Chenies St Chambers Leaseholders Association

Planning Application 2021 – 3704-P

Image 1

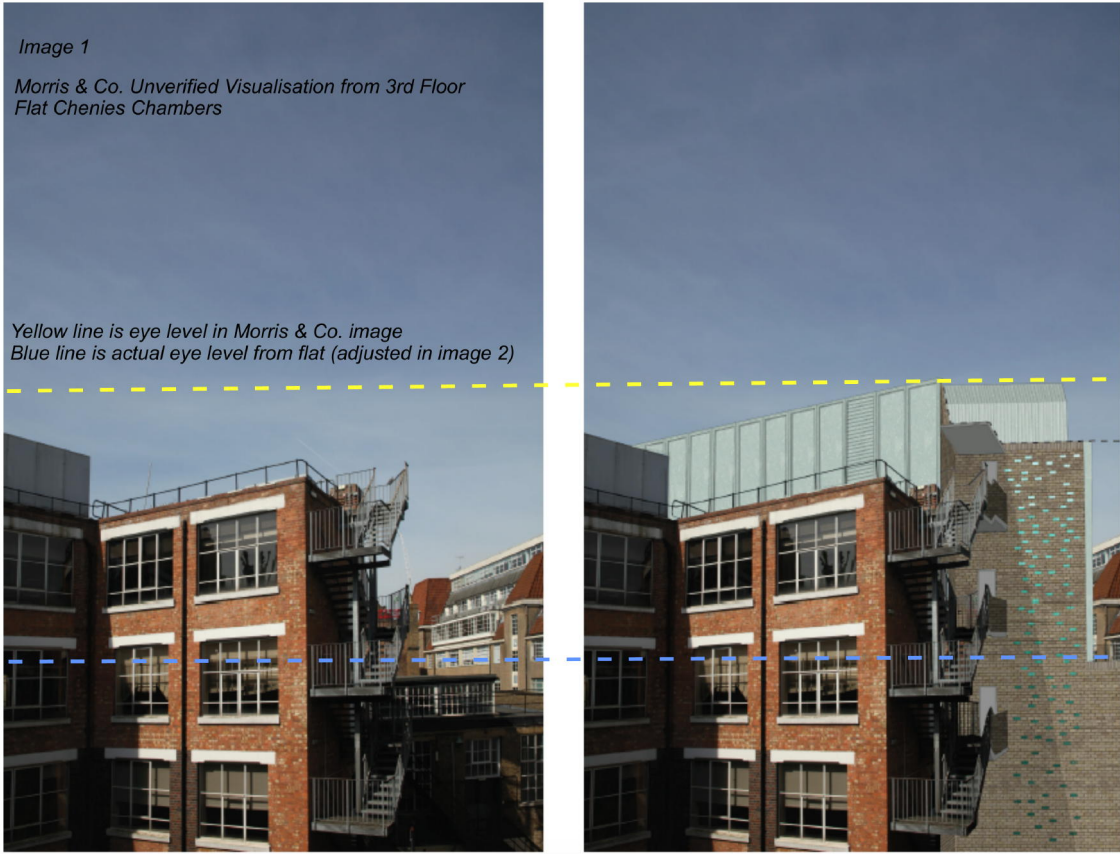
4. In the original application there were no visual representations of the plans from the rear of Chenies St Chambers. One was subsequently prepared but, as we have pointed out to the developer, this is misleading as it does not show an accurate view from the flat. The view shown is unverified. We attach the view taken from one of the affected flats - the view from which will now be a blank wall running higher than any of the buildings around. We believe the developer should show visual images that are verified views, as they are taken from each floor of the block to enable the planners to understand the impact.
5. One resident has asked on a number of occasions for photographs to be taken from a number of different viewpoints (as has been undertaken for the neighbouring block) – yet the developer has refused more than one image.

Yellow line is eye level in Morris & Co. image
Blue line is actual eye level from flat (adjusted in image 2)
